Minute No. 253
Report - Standing Policy Committee on Property and Development - March 25, 2008

Item No. 5 Amendment to Development Agreement AG 51/05 - Sage Creek (St. Boniface Ward)
File DASZ 32/2007

Re: **Requested amendment to Development Agreement AG 51/05 (Sage Creek)**
Qualico Developments (Winnipeg) Ltd.

Re: Qualico® - Sage Creek Subdivision – Tansi Lane

FIG "A"

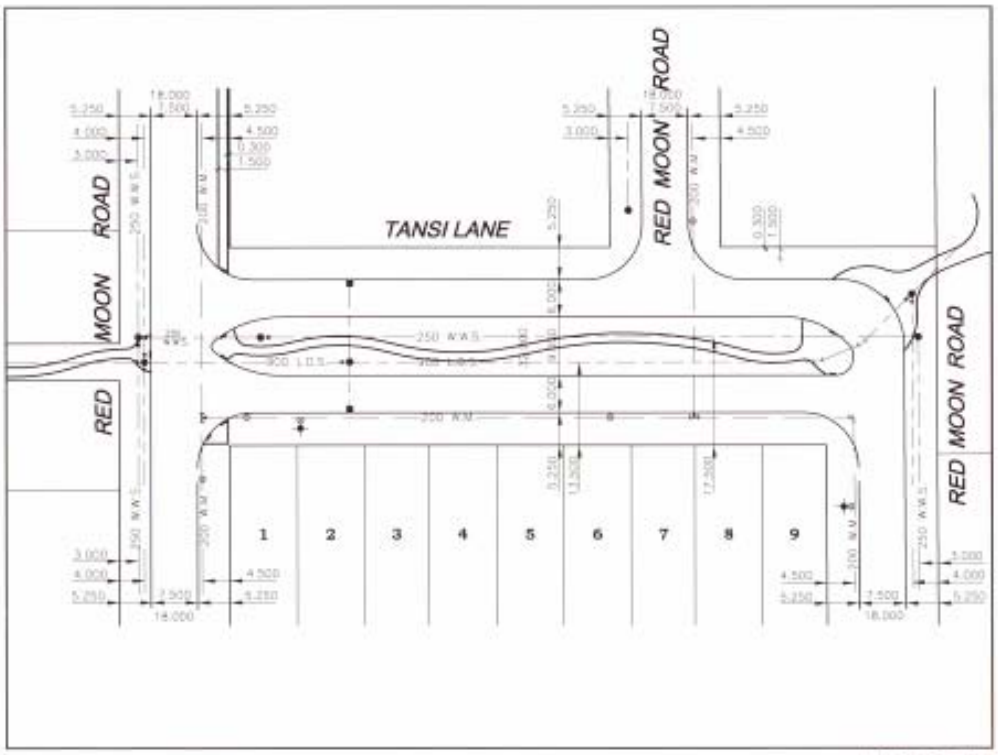
An issue has arisen regarding a request from Public Works to construct a public sidewalk on both sides of Tansi Lane which connects the north and south legs of Red Moon Road. Refer to Figure "A" attached.

At a significant cost to the Developer, Tansi Lane was constructed as a twin 6.0m pavement residential street with a wide median separating the two lanes to provide an "open" feel to the street with a central landscaped focal point, and at the same time contribute to the uniqueness of the neighbourhood. The Developer has a strong concern that public sidewalks would have a negative affect on the character of this street, given the 101' building setback. Refer to Figure "B".

This street could have been designed as a standard 7.5m roadway / 18m Right-of-Way as there was not a requirement for the twin pavement here for emergency second access. In accordance with City Standards, a typical residential street such as this would not require sidewalks.

- Reduced maintenance requirements for the City,
- Increased snow storage,
- A public walkway has been provided in the center median which connects with the developments pathway and park system,
- Four party utility servicing is installed on the 1.5m alignment on both sides.

The Public Works Department has no objection to deleting the requirement for 1.5m by 100mm sidewalks on both sides of Tansi Lane in consideration that the centre median pathway satisfies the sidewalk requirements at this location.
